## Product Advisor (PA)

**Subject:** Datasheet Correction for Listed Intersil ISL55012IEZ-T7 and ISL55014IEZ-T7\* Products

Appendix A – Datasheet changes

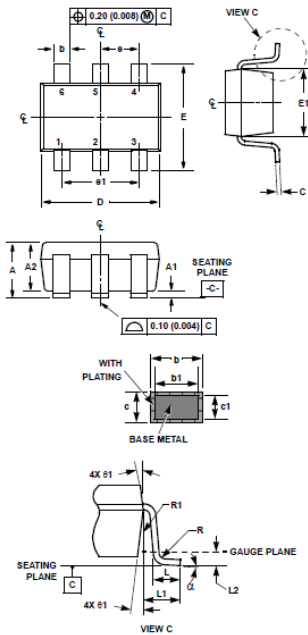
The datasheet for the listed ISL55012\* and ISL55014\* products has been updated to correct the Theta Ja value from 200 °C/W to 255 °C/W and include the correct package outline drawing (POD) as shown in appendix A.

**P6.049A**

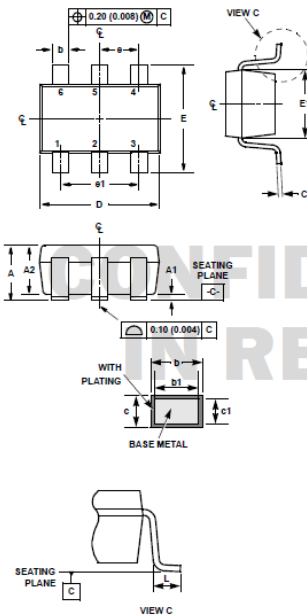
From:

To:

**P6.049B**
